16055A-01

## S E R V I C E N O T E

### 16055A Test Fixture

#### Banana Plug (1251-8936) is Discontinued.

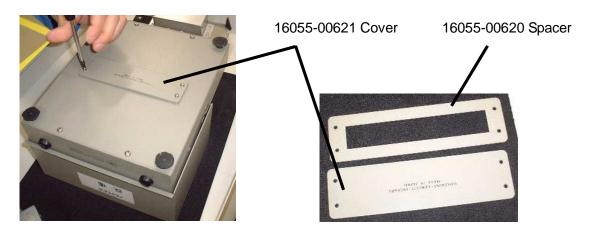
The banana plug (1251-8936) is discontinued.

The replacement part of 1251-8936 is 5185-2134.

You need to replace some other parts when you replace the banana plug.

1. Check if the 16055A has the cover on the bottom as shown below.

- 2. If the cover is attached, replace banana plug only.
- 3. If the cover is NOT attached, order all banana plug, chassis, bottom cover, spacer, cover, and screw. And replace them as follows:
  - A) Remove the bottom cover.
  - B) Remove the chassis.
  - C) Remove all banana plug, insulator, and nuts.
  - D) Attach the banana plug to the chassis 16055-60102 as shown below.
  - E) Attach the chassis.
  - F) Attach the bottom cover 16055-60022.
  - G) Attach the spacer 16055-00620 and cover 16055-00621 to the bottom with four screws.
